MUMBAI METRO RAIL CORPORATION LIMITED

Invitation of Bid For, “Design, Manufacture, Supply, Installation, Testing and Commissioning of E&M works comprising of Electrical Sub Stations with HT and LT works, Ventilation and Air Conditioning Systems (VAC), Fire Detection Systems, Fire Suppression (Fire Fighting) Systems, Building Management System (BMS), EOT cranes, Air-Compressors including compressed air piping works and Plumbing Pumps for the Depot Buildings including OCC and at grade Aarey Station for “Mumbai Metro Line -3”

Contract No: [MM3-CBS-DEM]

Addendum No: 7

PROJECT	MUMBAI METRO LINE 3 COLABA-BANDRA-SEEPZ		DATE	JAN 2018
TITLE	EOT CRANE GENERAL ARRANGEMENT DRAWING	DRAWING TITLE	TYPICAL EOT SCOPE OF WORK DEM & CIVIL	
DRAWING NO	MM3-GC-DIM-GD-08-D07-0106	SCALE	NTS	
DRAWN BY		NAME		
DESIGN BY		SIGN		
CHECKED BY				
APPROVED BY

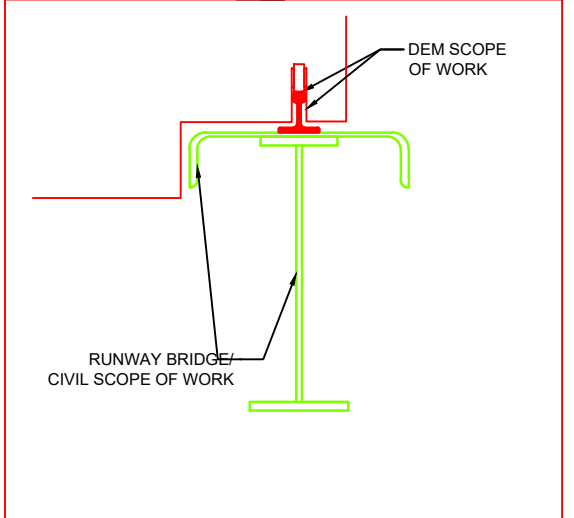
Sr. No	Reference Clause no. and Description	Existing content to be deleted	To be replaced as
			Address:- Worli Seaface Branch,Mumbai IFSC Code:- HDFC000080 BSR Code:- 0510093 Swift Code:- HDFCINBBXXX MICR Code:- 400240022
7	Volume-5-Tender Drawings Attachment-12 to Addendum-5	Drawing No-MM3-GC-DIM-GD-08-D07-0106 (R1)	Refer attachment:-1 Drawing No-MM3-GC-DIM-GD-08-D07-0106 (Rev2)
8	Volume-6 B4-2 Sub Section - 2- EOT CRANE 2.1-b	Inspection Bay: 2 Ton The rate include Design, manufacture, supply, installation, testing and commissioning of 2T EOT Crane for span 9m, bay length 295 m with Main hoist motor along with accessories, and long/cross travel motors along with accessories. Crane will be provided on inspection bay with special girder system in the bay. Cranes will also be controlled from pendent switch and radio remote control. All the wire ropes along with hook, rope drum and necessary safety devices etc. Necessary arrangement of 3-phase power supply for working the crane throughout the long travel length along with current collection system. The EOT crane shall be complete in all respects and as per technical specifications. (In single bay with individual operation control / pendent)	Inspection Bay: 2 Ton The rate include Design, manufacture, supply, installation, testing and commissioning of 2T EOT Crane for span 15m , bay length 295 m with Main hoist motor along with accessories, and long/cross travel motors along with accessories. Crane will be provided on inspection bay with special girder system in the bay. Cranes will also be controlled from pendent switch and radio remote control. All the wire ropes along with hook, rope drum and necessary safety devices etc. Necessary arrangement of 3-phase power supply for working the crane throughout the long travel length along with current collection system. The EOT crane shall be complete in all respects and as per technical specifications. (In single bay with individual operation control / pendent)

REV.	DATE	PREP.	APPROVED	DESCRIPTION
R2	25/01/18			MODIFIED AS PER TECHNICAL REQUIREMENT
R1	11/12/17			MODIFIED AS PER ARCHITECTURAL CHANGE

Bogie workshop Area
Capacity = 2 T
Span = 14.50 m
Bay length = 96 m
QTY = 1No
